Customer Service Bulletin
Commercial Business Group

Sand Pro® 5020 May 9, 2002

Subject: No Start Condition from Corroded Starter Switch (Key Switch).

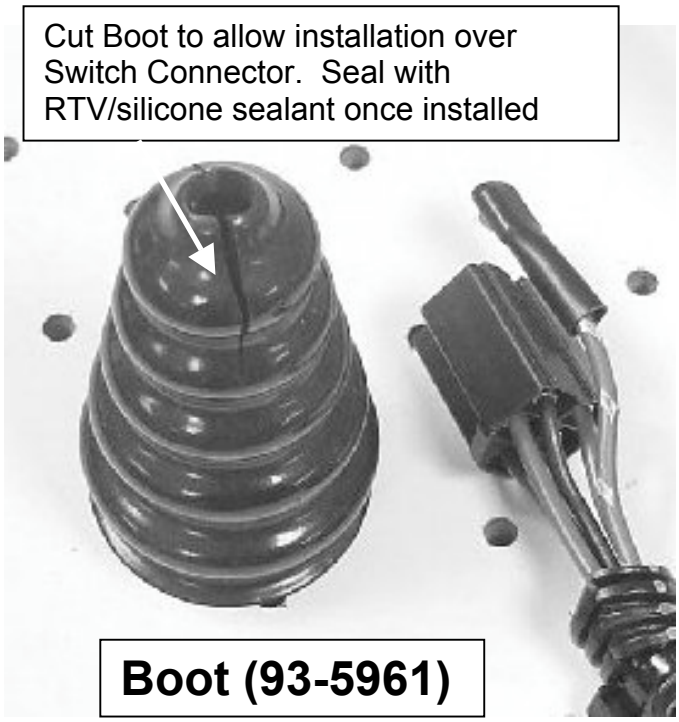
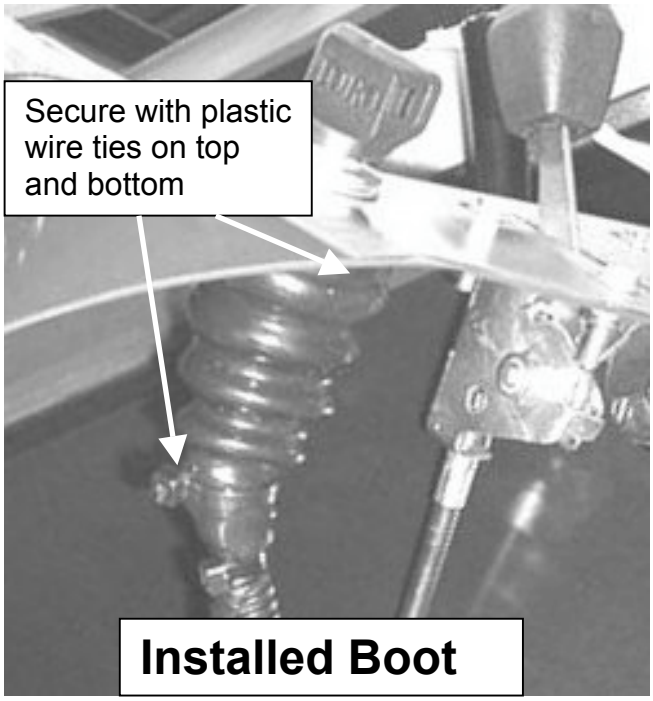
The backside of the Starter Switch is susceptible to sand and moisture thrown by the rear wheel as it turns. Chemicals and water associated with turf maintenance can corrode the electrical contacts and result in Switch failure.

A Boot (93-5961) can be installed over the Starter Switch body and connector harness to shield the backside of the Switch from debris and moisture. The Boot must be cut to allow the connector body to pass through Boot. Once installed, secure Boot to harness and Switch body with plastic wire ties. Seal the cuts made to Boot with silicone sealant.
